PRODUCTS: Utica Boilers - Hotline Series Indirect Water Heater

Subject: Coil Change

Models Effected: HL-30, 40, 50, 80 & 119

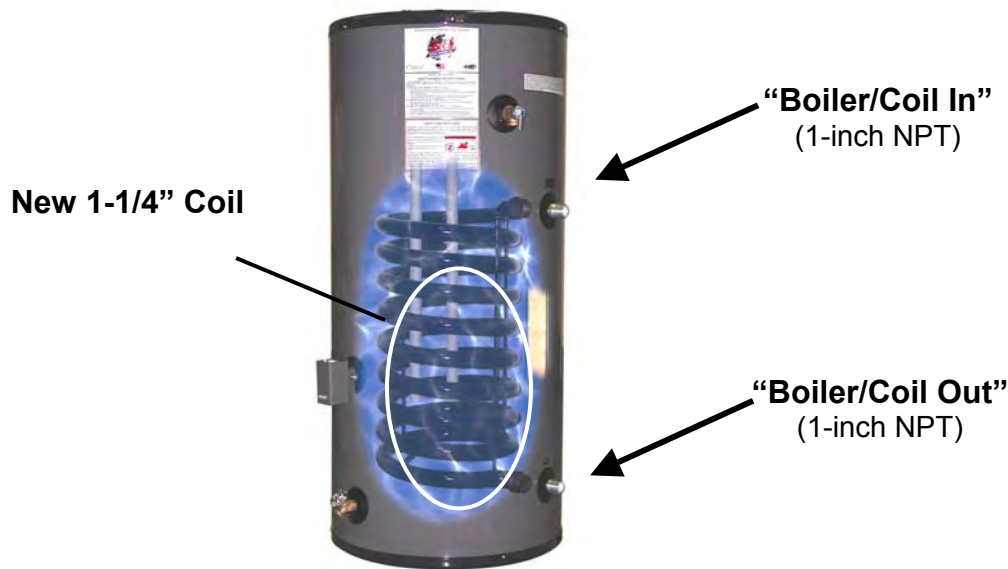
Effective immediately the HotLine Series Indirect Hot Water Heaters have changed as follows: (see illustration below)

- HL30, HL40 & HL50 have relocated their "boiler/coil in" and "boiler/coil out" tapings. Previously on the top, these connections are now on the side of the tank.
- All HotLine sizes (HL30 - HL119): Internal coil diameters have increased from 3/4" to 1-1/4". Coil connections for all sizes will now be 1-inch NPT.

NOTE: The change in the coil does not effect the location or size of the domestic Hot and Cold connections.
